Addendum #2

Project Name: New Residential Housing Facility for the Bridges Project.
Southern Hills Drive / NE State Spur 1C @ US Highway 6 & 34 Hastings NE.
Project No.: 10087
Issued: March 30, 2012
Bid Date: 3:00pm, Thursday, April 5th, 2012
Bid Opening: State Building Division – Suite 400
Location: 521 South 14th Street, Lincoln, NE 68508-2707

2" POTABLE SUBMERSIBLE WELL
 NOT TO SCALE

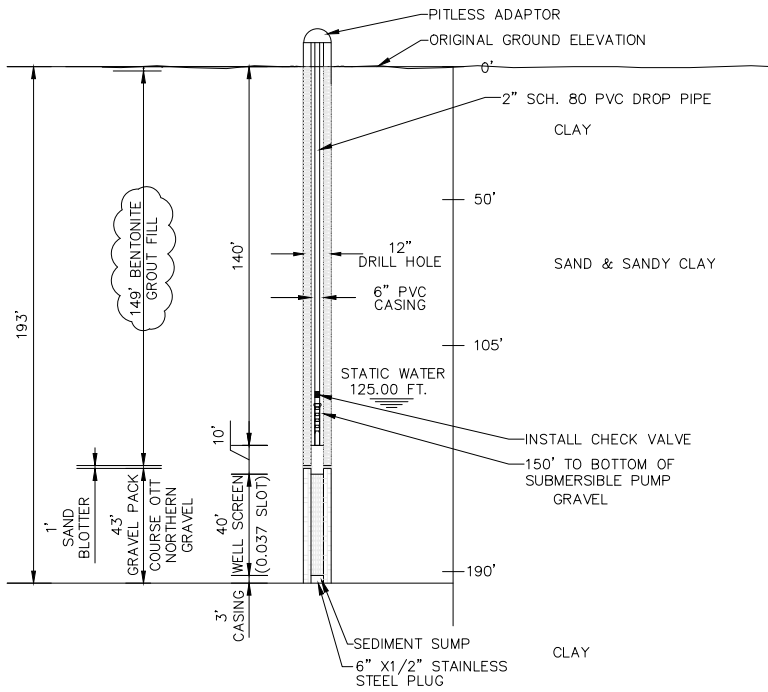
1. Refer to Detail “2” Potable Submersible Well. The grouting of the well has been revised. The grout has been changed from partial bentonite and partial concrete to all bentonite. Refer to the attached exhibit included with this addendum.
